SAFETY RECALL

Tail Lamps

Reference: 90B / NHTSA 24V-585

Remedy available for
2024 (JL) Jeep Wrangler

Figure 1 – Replace Both Tail Lamps with Lamps Including a Spacer Bezel

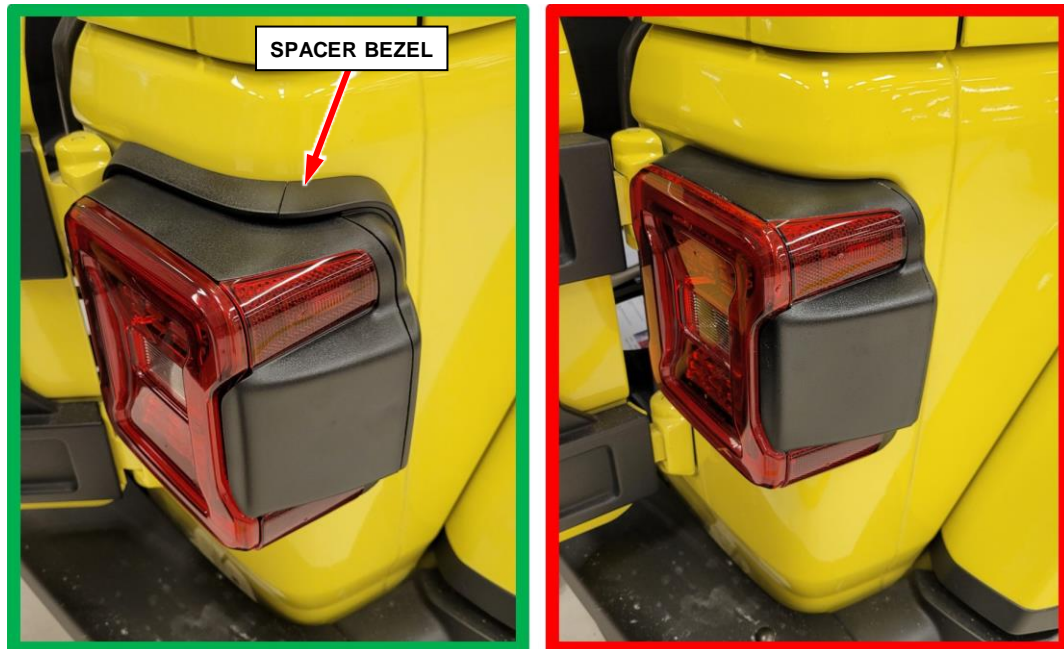
1. Replace both tail lamps with NEW tail lamps which include a spacer bezel (Figure 1).

Correct Tail Lamp With Bezel

Incorrect Tail Lamp Without Bezel
